**MONTGOMERY COUNTY
PLANNING COMMISSION**

Re: MCPC #19-0060-003

Plan Name: Lower Merion School District – Middle School
(1 lot/218,000 sq. ft. institutional on approximately 22.23 acres)
Situate: West Montgomery Avenue (west)/south of Saybrook Road
Township of Lower Merion

Attachment A: Reduced Copy of Applicant's Proposed Site Plan
Attachment B: MCPC Comments on Applicant's Proposed Site Plan
Attachment C: Aerial Image of Site

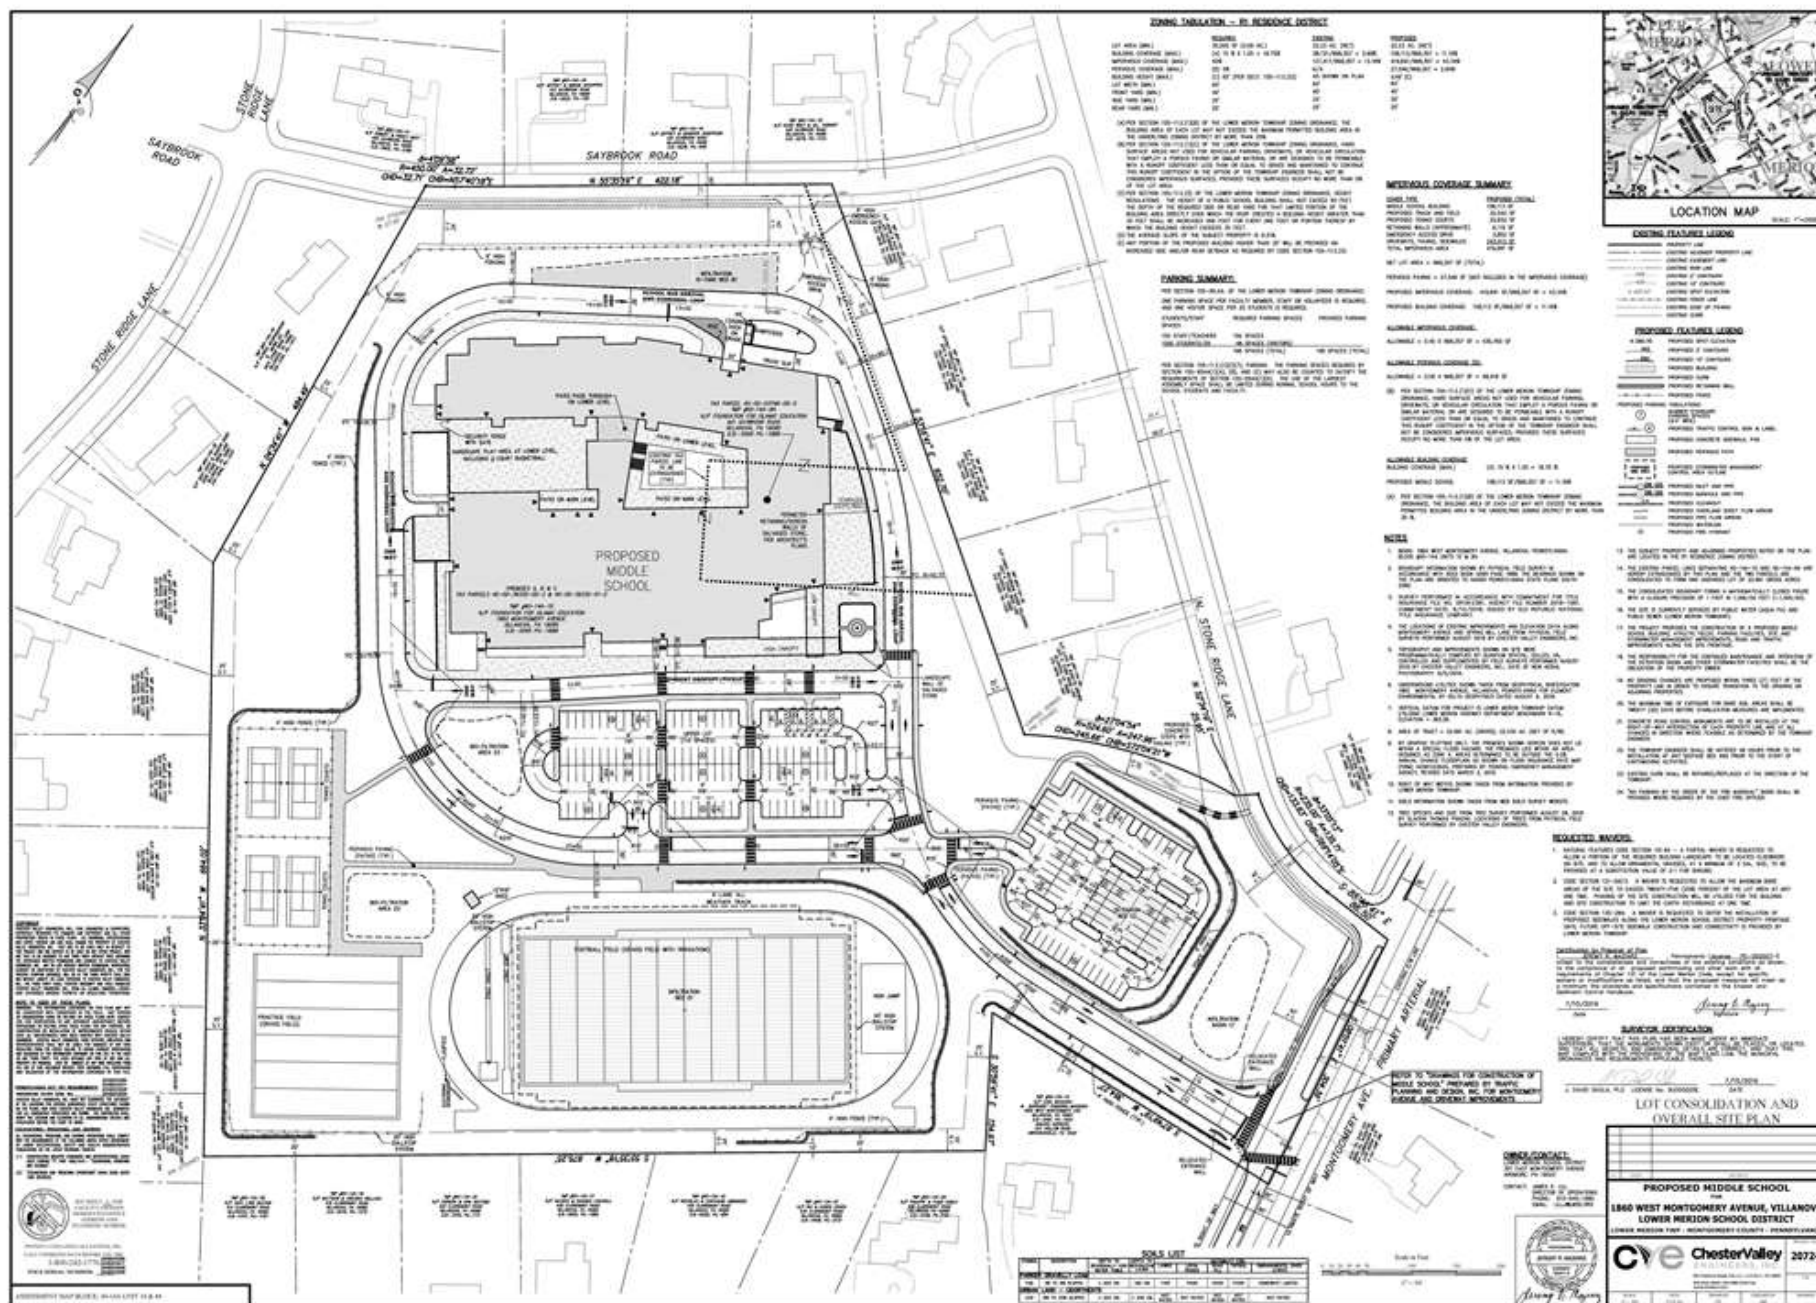
2. Potential Pedestrian Connection to Saybrook Road. We understand that the applicant is proposing to construct a fence along the Saybrook Road frontage of the site for security reasons that could limit pedestrian access into the middle school site. However, we feel that a potential pedestrian connection from the Saybrook Road frontage could still be considered in conjunction with a slightly reconfigured security fence. For example, if the security fence was constructed so that it extended further into the site along the edge of the bus loop driveway, a pedestrian path could potentially be provided between the bus loop driveway and the eastern property line. In this configuration, the pedestrian pathway could extend into the site and pedestrians could cross the bus loop driveway at the proposed crosswalk closest to the main public entrance to the building. Please see Attachment B for an illustration of this concept.
